M E M O R A N D U M

Date: November 18, 2014  
To: Hugh Russell, Chairman, Cambridge Planning Board  
From: Tanya Iatridis, Senior Director of University Planning, HPPM  
Copy: John Haigh, Executive Dean, Harvard Kennedy School of Government  
Re: Planning Board Requirements – Special Permit Application #293

To: Harvard  
From: CDD Staff  
Date: November 4, 2014  
Re: **Harvard Kennedy School of Government – Planning Board requirements**

# ELIOT STREET ENTRANCE

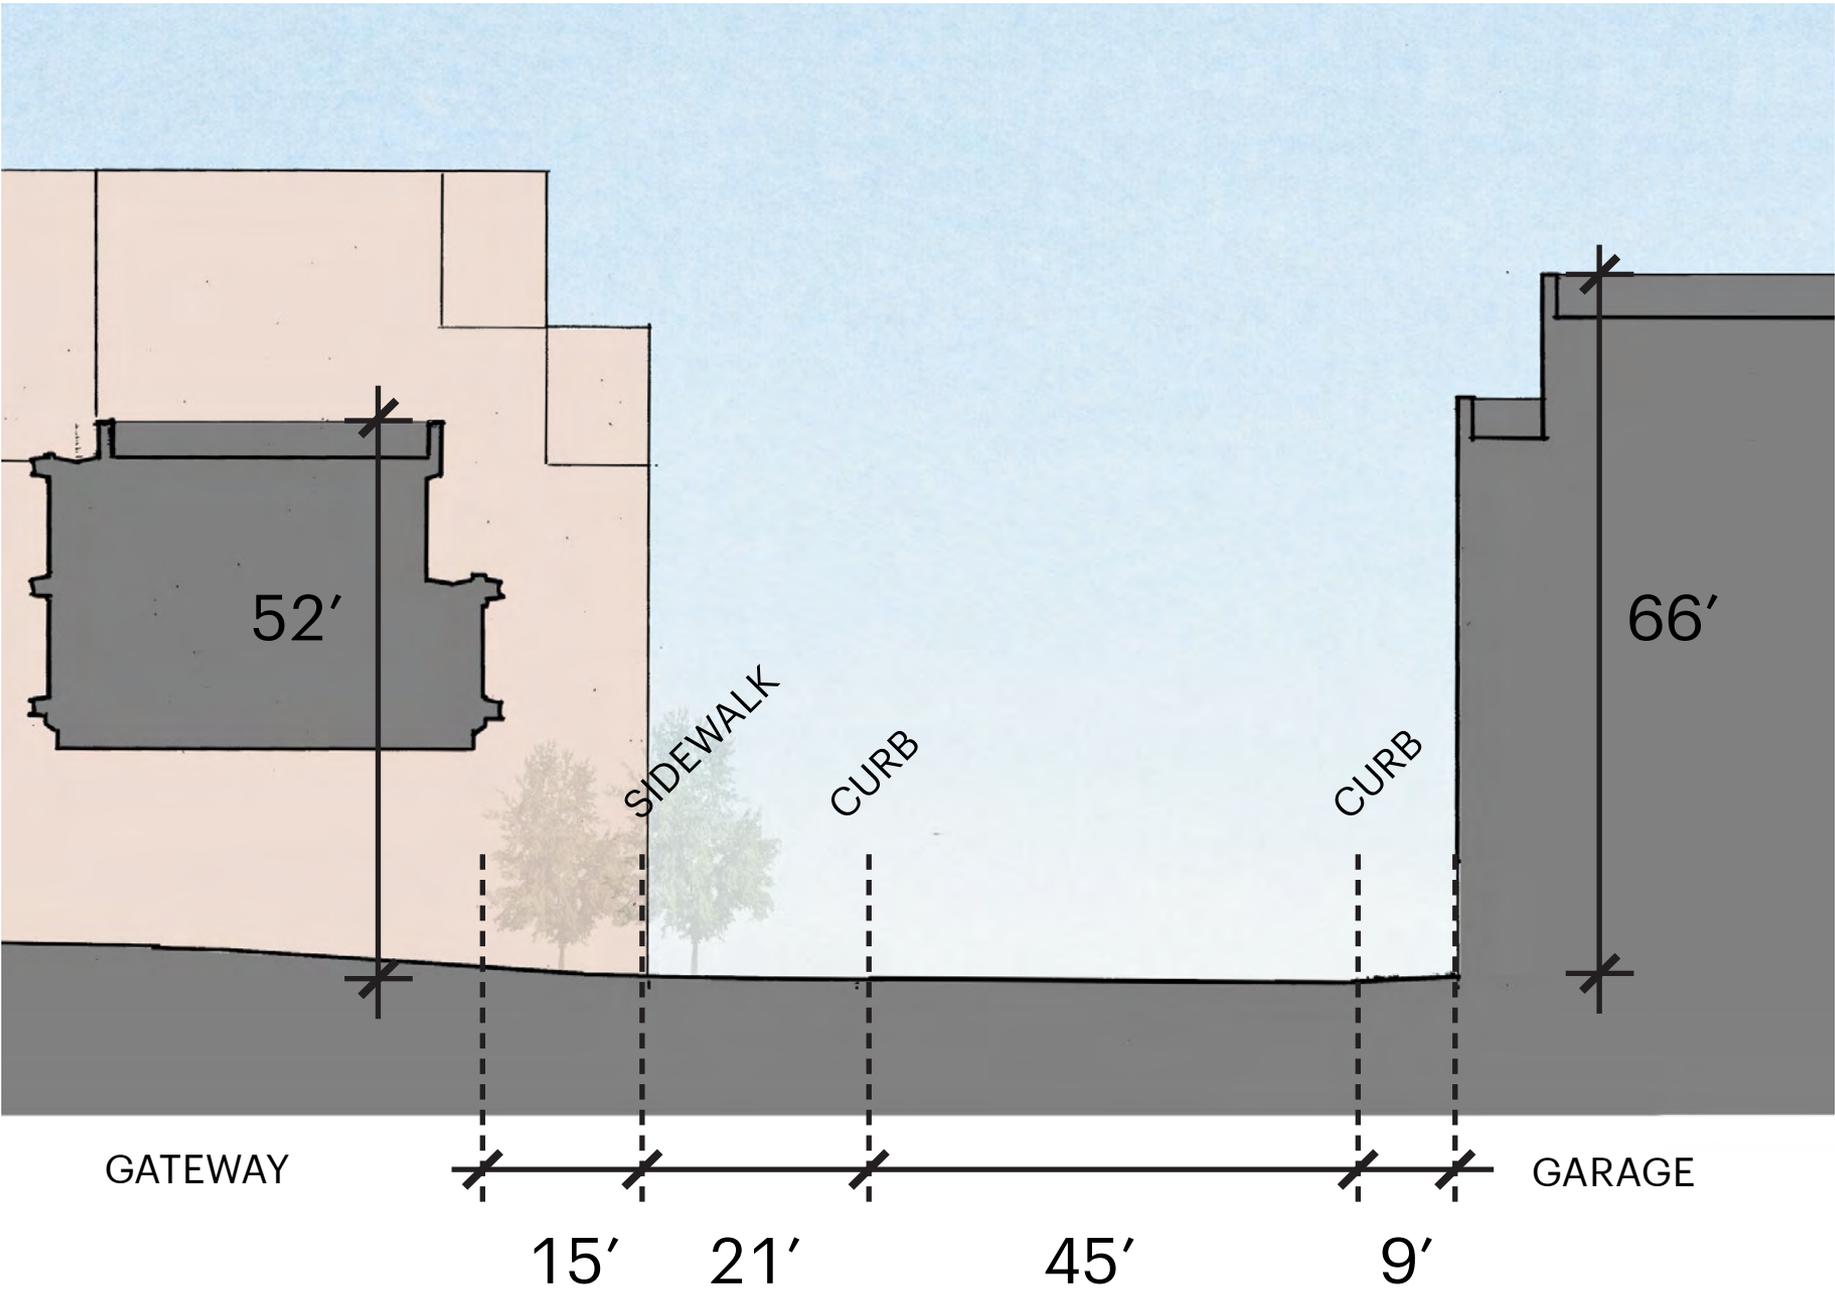
- The proposed security bollards and screen to be used for the Eliot Street entry seem inconvenient and unattractive. The Planning Board would prefer to see use of screens or gates that are of the same design quality as other Harvard gates – consider black finish and use of Harvard logo.
- Clarify proposed landscaping and paving at front of Taubman Building entry, including relationship with the allée's granite markers.
- Bicycle parking has potential to be better designed and integrated. This needs to be addressed prior to the next hearing.
- Provide more detailed landscaping plans that incorporate all the modifications proposed at last Tuesday's hearing and those suggested above - focus on building and courtyard entries.

The Eliot Street entrance is intended to remain open 24/7 without any physical restrictions to access (See Attachment 6-1). The security bollards and screens proposed at this entrance will be used only when HKS is required to secure the campus at the directive of public safety officials. Based on campus operations history over the past two years, the existing entry gates at Eliot Street were closed an average of four hours on six occasions per year; a total of 24 hours per year.

Given the limited nature of its intended use, a security gate system that is modular and can be readily installed, removed and stored out of site when not in use, remains the preferred alternative. HKS has amended the design to incorporate features such as a black finish and a Harvard insignia that are consistent with the character of other Harvard gates (See Attachment 6-2).

A security gate system more akin to the one proposed at the West entry (a retractable metal fence) was studied and it would require gate sections to remain permanently in place due to the size of the opening and the inability to completely conceal the gate sections within the site when not in use (See Attachment 6 -3). Given the comments on this topic, this would not appear to be a satisfactory design solution from either the perspective of HKS or the public.
